McElroy Manufacturing, Inc.

DWG No: 2462600

630MM McHiLYT PLUMBING SCHEMATIC

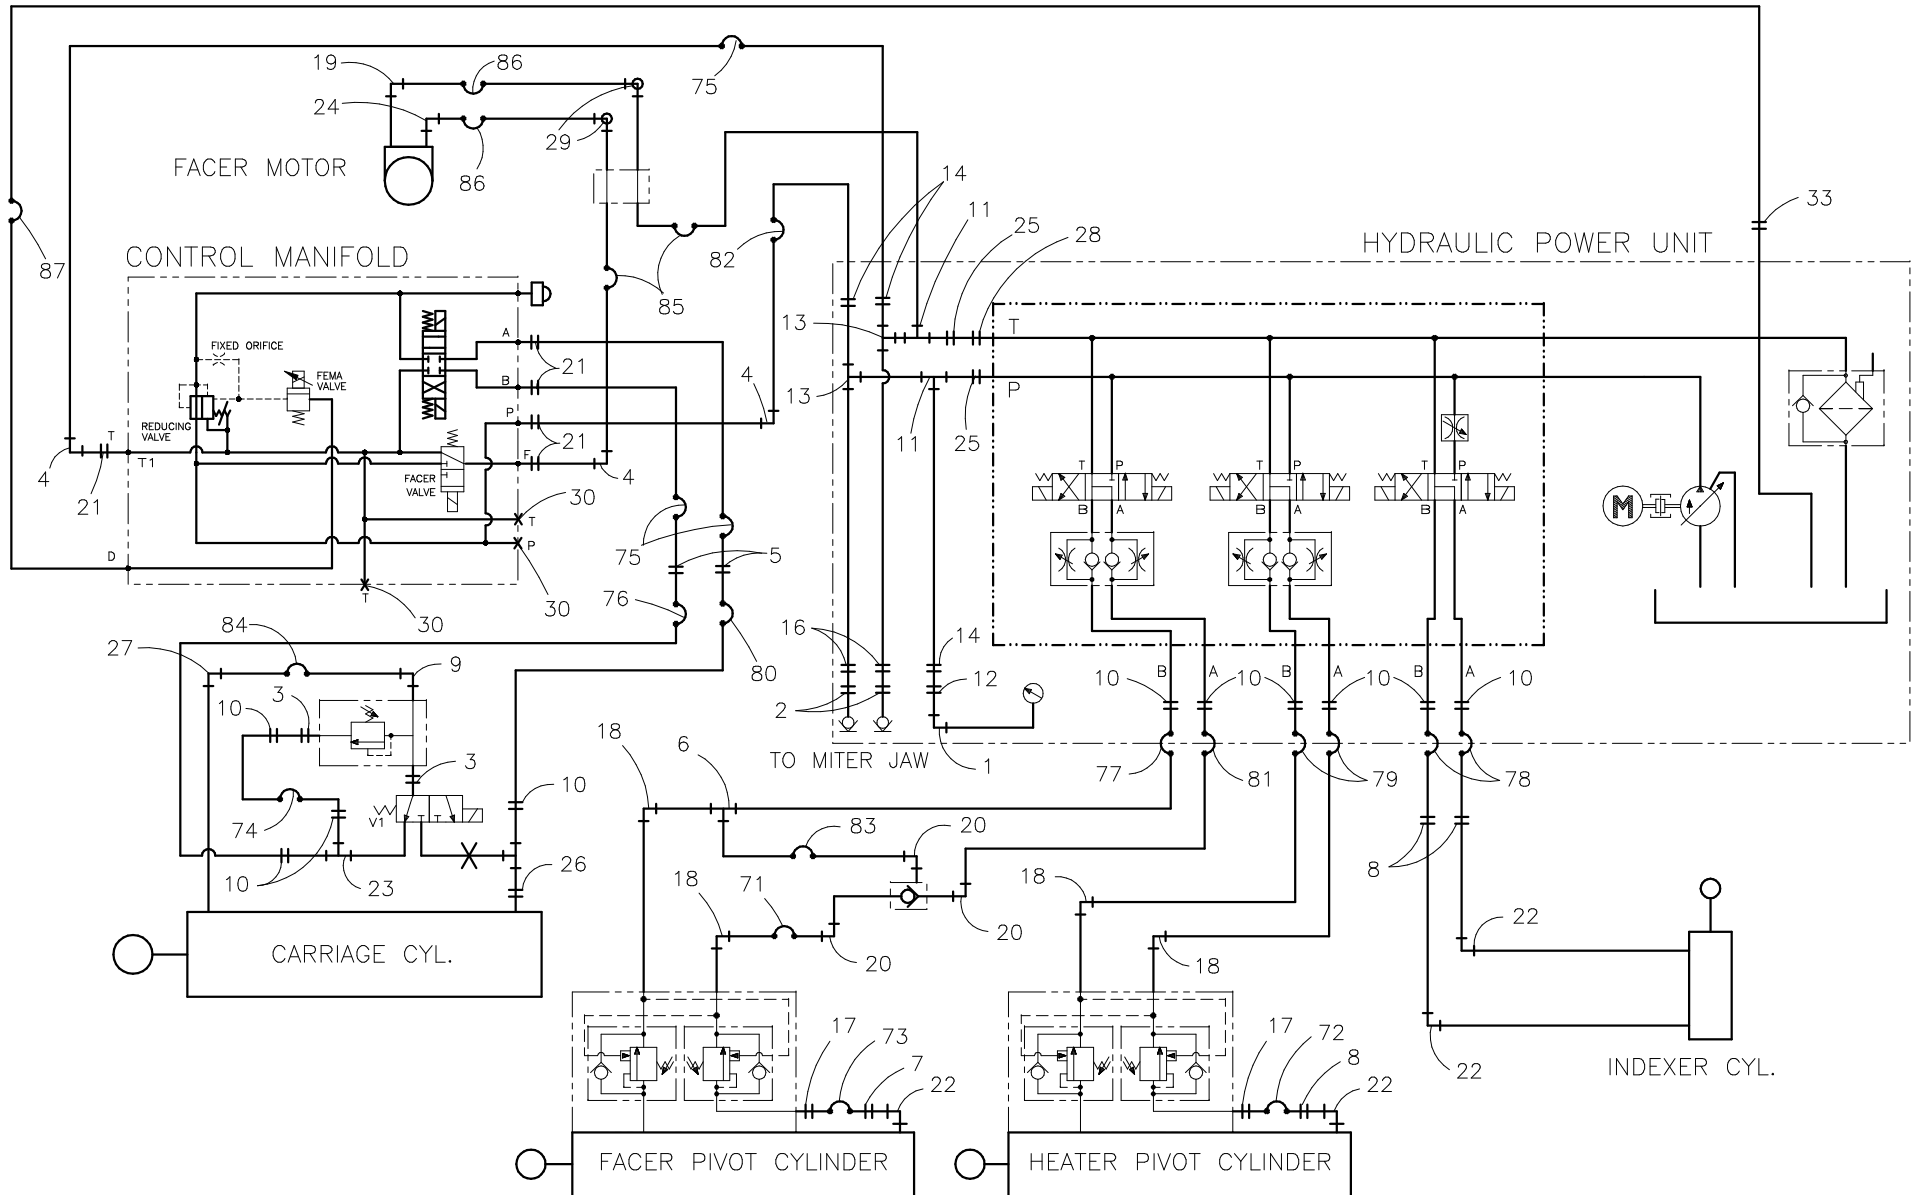
<u>APPR.</u>	<u>REV</u>	<u>DATE</u>	<u>BY</u>	<u>DESCRIPTION OF REVISION</u>
RAD	A	4/14/00	MLM	ITEM 5 WAS QTY 4 NOW 2. CHANGED ITEM 10 FROM MFB00076 TO MFC00105. ADDED ITEMS 31-MFB00076, 32-MFB00075, AND ITEM MFB00006. ADDED HOSE ASSEMBLIES.
